# UNITED STATES PATENT AND TRADEMARK OFFICE

APPLICATION NO.	FILING DATE	FIRST NAMED INVENTOR	ATTORNEY DOCKET NO.	CONFIRMATION NO.
10/067,161	02/04/2002	Dennis Robert Kliegle	24950A	4940
22889	7590	07/11/2005	EXAMINER	
OWENS CORNING 2790 COLUMBUS ROAD GRANVILLE, OH 43023			GREEN, CHRISTY MARIE	
			ART UNIT	PAPER NUMBER
			3635

This is a fifth office action for serial number 10/067161, entitled Suspended Ceiling Panel Edge and Rib Technology, filed on February 4, 2002.

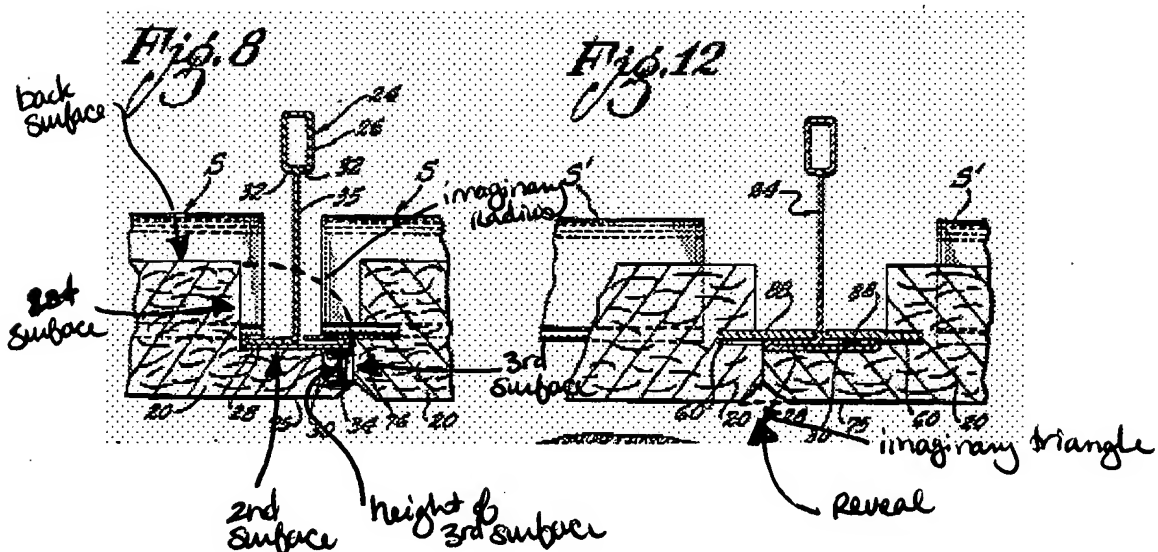
Claims 1, 2, 4-7, 10-12, 38-41 are rejected under 35 U.S.C. 102(b) as being anticipated by Stanley, US patent # 3,032,833.

Stanley discloses the claimed invention a surface panel (20) with a major and minor dimension and a thickness dimension, a side edge of the panel corresponding to the thickness dimension, a face surface (at 75 – figure 8) of the panel facing toward a room and substantially coplanar with a plane defined by the major and minor dimensions, a back surface (see figure 8 on the next page) of the panel being opposite

of the face surface, the panel edge is multifaceted and includes a first surface intersecting the back surface (see figure 8 below), a second surface intersecting the first surface and substantially parallel to the face surface (at 75), a third surface (figure 8 below) intersecting the second surface and substantially orthogonal to the face surface, and a fourth surface (figure 3 below) intersecting and being beveled relative to the third surface, two of the surface panels (20) are located adjacent one another, the third surfaces abut without intervening framing material (figure 8), and the fourth surface is arranged so as to represent a surface of a triangularly grooved reveal (figure 12 below); the fourth surface intersects the face surface (at 75); the first surface is substantially orthogonal to the back surface (figure 8); the surface panel is a ceiling panel for suspended ceiling (shown in figure 10); the surface panel is a wall panel (interpreting the ceiling to be a wall); a height of the third surface is about half of the distance between the second surface and the face surface (see figure 8 below); the fourth surface is a continuous surface (by continuing into the face surface and the third surface); the third surface is more outboard, relative to an imaginary radius (figure 8 below) extending from a center point of the panel and sweeping out an imaginary plane

substantially parallel to the back surface, than the first surface; the first, second, third and fourth surfaces together present a generally convex conformation (figure 8); the fourth surface is substantially planar (figure 8).
